**PROBLEMS WITH THE  
EU STRESS TEST  
SWISS NATIONAL REPORT  
AND THE MUEHLEBERG NPP**

**DRAFT 3**

M. KUEHNI

M. Kuehni  
 Assessor for Greenpeace, Switzerland  
 +41 79 294 03 31  
 mailto:markus@zbern.ch

**Fig. 2 New Safety Concept for the Mühleberg NPP**

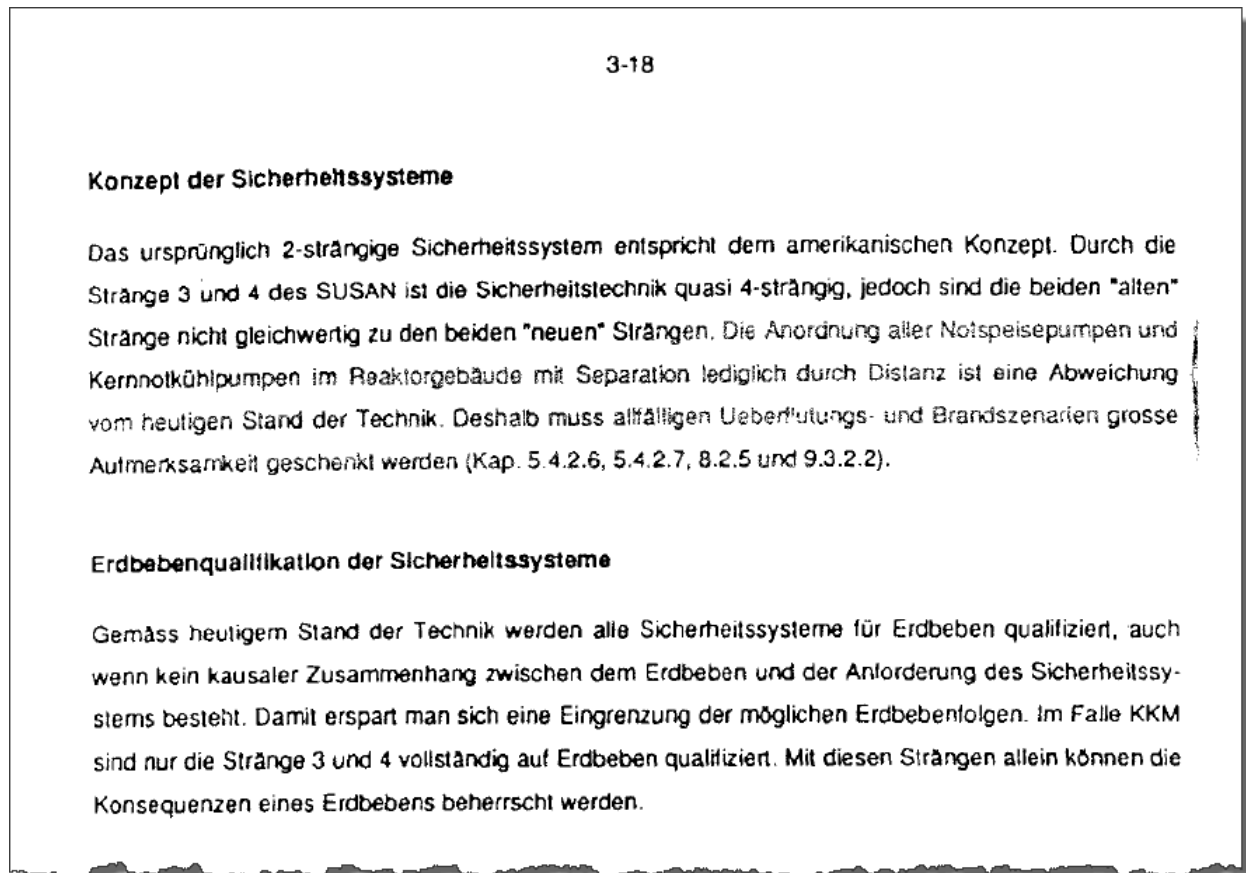
The concept is clear: just the new SUSAN safety train (redundant lines no. 3 and 4) are really earthquake qualified. Only these can be credited to control the DBE.

**Fig. 3 Plant layout from HSK91**

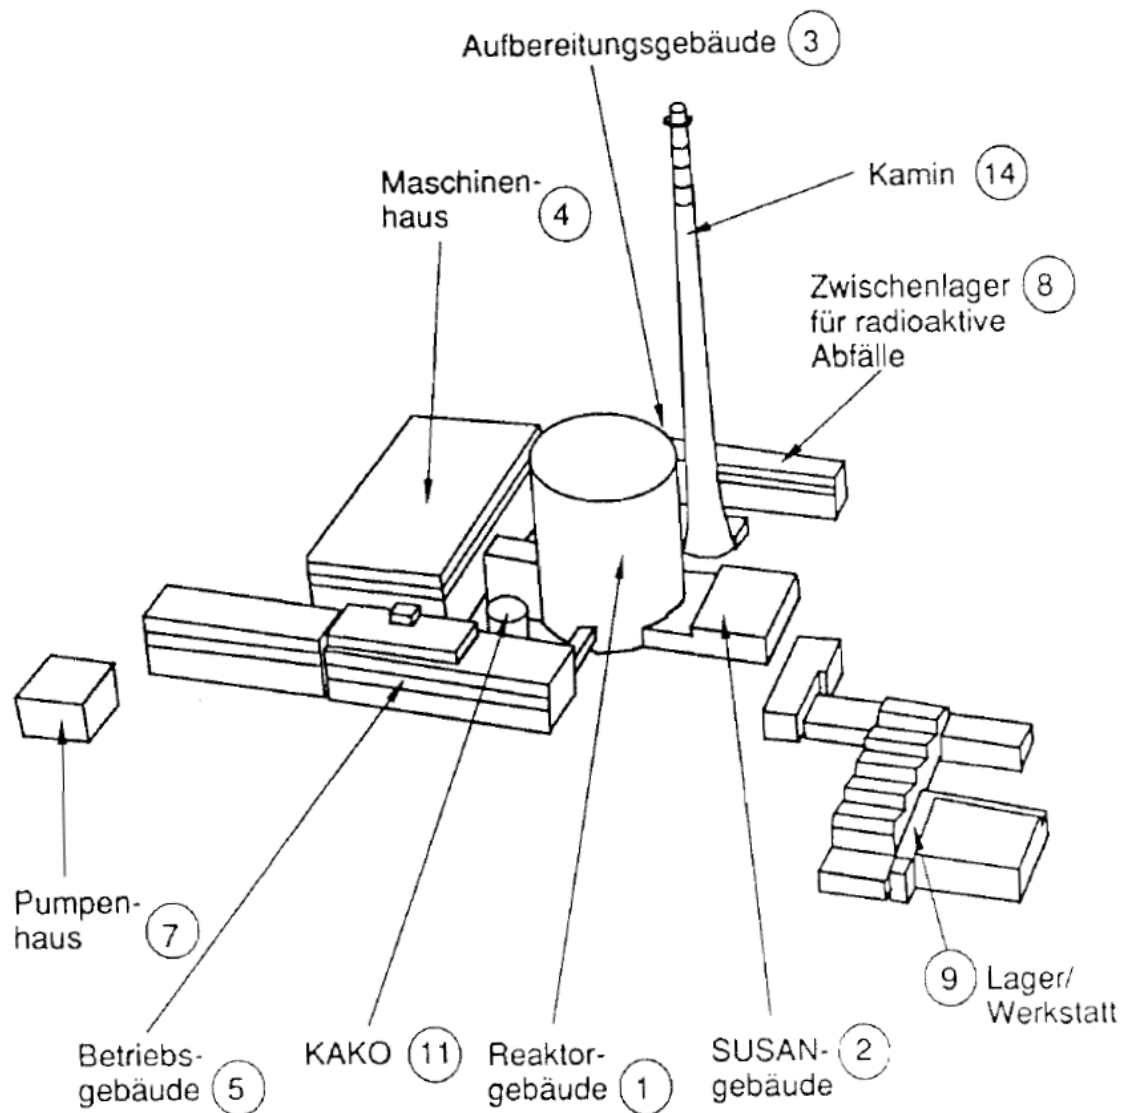
The reason is clear: the support buildings, where some components of the old safety train are located, are not earthquake qualified (more precisely: they failed earthquake requalification). These are pump house (7), operations building (5) and machine house (4):

These buildings host water intake, band screens, pumps, etc. (7), main control room, switchgear, batteries, etc. (5) cooling water lines, diesel generator, diesel tank, etc. (4).

**Fig. 6 enlargement of the above photo looking into the control room (Note the process visualization screen with typical GE BWR Mark I design).**

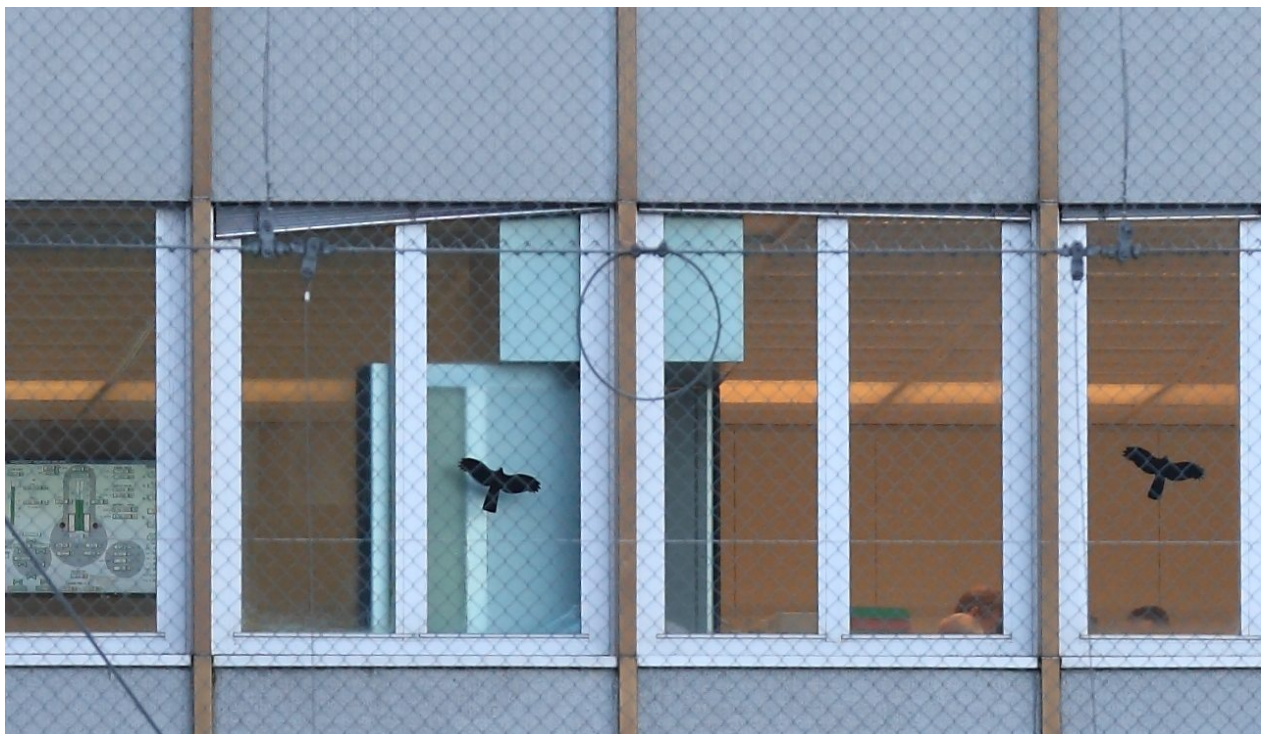
The Mühleberg NPP control room is not earthquake proof. It is situated on the second floor on +8m in a plain office style building of the minimalistic<sup>10</sup> boom years quality typical for the 1968 build date:

Consequently the control room is not safety classified for the safe shutdown earthquake (SSE) according to the 2005 PSR<sup>11</sup>. The building is classified for the operating basis earthquake (OBE) with peak ground acceleration of 0.06g “and some margin” (0.09g documented in HSK91, p. 6-17). For any earthquake stronger than that, it has to be assumed that the building will collapse and all operator personnel trapped, injured or killed.

**Fig. 11 KKM in the precipitation DBF +0.25m flood. Elevation data 1:25'000 by Swiss Topo, interpolated, 5m mesh.**

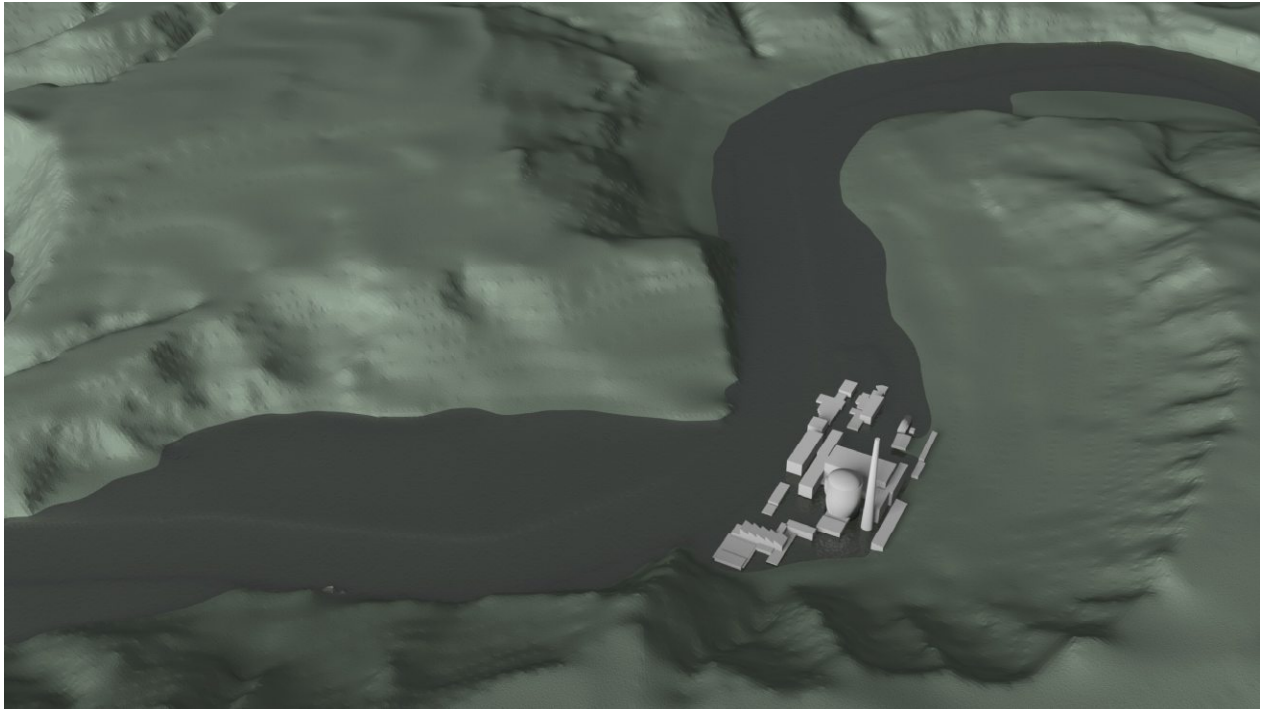
After Fukushima, ENSI ordered the precipitation flood hazard to be re-examined by the plant operators. The reassessment revealed that the precipitation flood actually surpasses the earthquake induced Mühleberg dam gates failure scenario. The plant is flooded by +0.25m.

More importantly, concerns of the author<sup>21</sup> were confirmed that bed load and sediment transportation could block the SUSAN cooling water intake and that the static “dead end” fine screen of the emergency water intake structure could be blocked by organic material (see section 5.4 for more detail on that).
